Preliminary Consultation
MONTGOMERY COUNTY HISTORIC PRESERVATION COMMISSION
STAFF REPORT

Address:	21 Quincy Street, Chevy Chase	Meeting Date:	5/27/2020
Resource:	Contributing Resource Chevy Chase Village Historic District	Report Date:	5/20/2020
Applicant:	Andrew and Jennifer Tulumello (Wouter Boer, Architect)	Public Notice:	5/13/2020
Review:	Preliminary Consultation	Tax Credit:	N/A
		Staff:	Dan Bruechert
PROPOSAL:	Building addition

Figure 4: 1st-floor plan, the red line indicates the exterior wall of the historic bay.

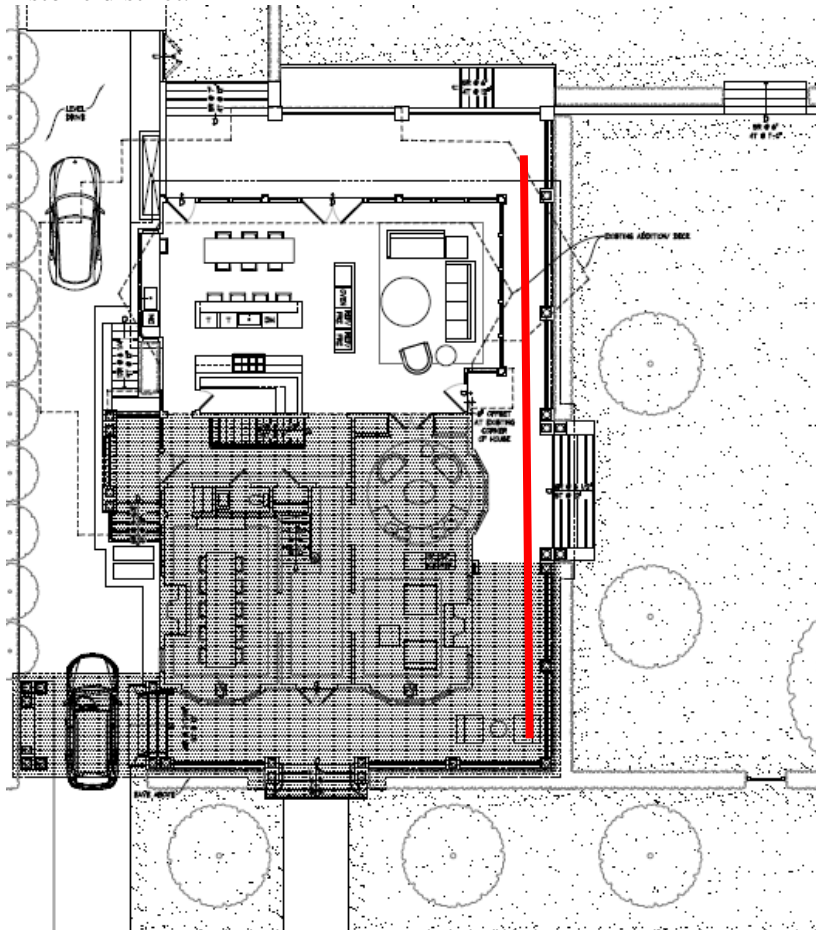
The first floor of the proposed addition is co-planer with the historic wall on the left (west) elevation. This is generally not a preferred solution, but in this case, there will be a visual separation between the building due to the mudroom addition. On the right (east) elevation, the proposed addition will project approximately 2' (two feet) beyond the exterior wall of the projecting historic bay. It appears that the east wall of the addition projects approximately 3' (three feet) from the historic wall plane (see Fig. 4, below). The second floor steps back and is inset several feet from the historic wall plane. Because the subject property is a double lot, the east elevation will be more visible than is typical in other locations within the historic district.

The preferred treatment is to have the walls of rear additions inset from the historic construction to provide a level of differentiation between the historic and the new construction; and to make the building addition less visible from the public right-of-way (per the *Design Guidelines*). Insetting the addition also allows the historic construction to maintain primacy on the site. Staff finds that there are no unique lot situations that would limit the ability to inset the east wall of the rear addition, or at the very least making the construction co-planer with the historic house.

However, Staff has identified three factors for consideration that when evaluated in concert with the Standards and 24A, may prove to be acceptable under the requisite guidance. First, the *Design Guidelines* state that the reason to place additions to the rear of the historic house is to reduce the visibility of the new construction. Because the subject property is on a double lot and the house is placed on the western (left) side of the lot, the east (right) elevation of the house and the addition will be highly visible regardless of how far inset the building addition is. The other factor to consider is the exterior appearance of the first floor of the proposed addition. By proposing a mostly glass first floor, portions of this addition will be see-through when viewed from the public right of way, reducing the visual impact of the construction. The final factor is the visual impact the extension of the wrap-around porch will have, obscuring a portion of the first floor of the addition's eastern wall.

- The appropriateness of projecting the east wall on the left elevation beyond the rear wall plane;
- If the addition wall plane has to be inset from the historic wall plane, by how much?
- If the width of the addition needs to be reduced, is it acceptable for the addition to project further toward the rear?
- Are there any other concerns regarding the size or massing of the proposed addition?
